寄件者: lasliechen <lasliechen@diva.com.tw>
寄件日期: 2025年1月10日星期五 下午 4:45
收件者: 'Coralie_Chen'
副本: 'Mary_Wang 王彥筑'; 'Chris_Lu'
主旨: RE: Hinge, 3MD332ME060
附件: 3MD332ME06A承認書+ROHS.pdf

3MD332ME060 扭力變更承認作業：
料號將會進階為：3MD332ME06A
請提出承認書兩樣品：
承認書如 3MD332ME060 之相關報告需要重新測試。
樣品需求 2pcs，提供給我司測試所有使用的機種是否可共用修改後的扭力。
扭力公差值是否縮小至 4 ?
扭力調至 68 kgf/cm

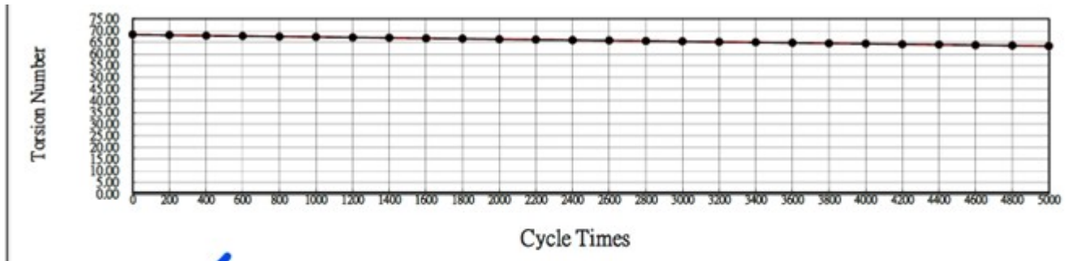
請確認一下壽命測試表格中的扭力值是否應該是 68，請更新報告，謝謝您~

誤植已更正請參照附件 ~Thank you !!

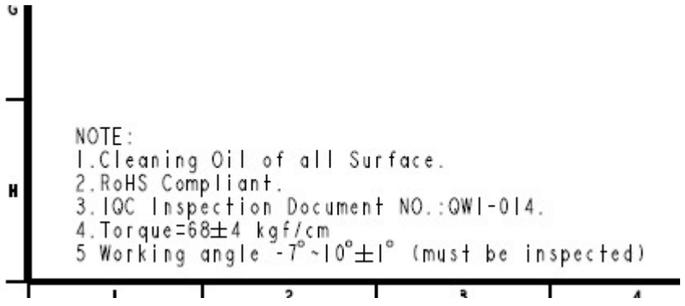
以上所有作業未完成之前，新的扭力值不會導入到新訂單。
有任何問題請提出討論，謝謝您~
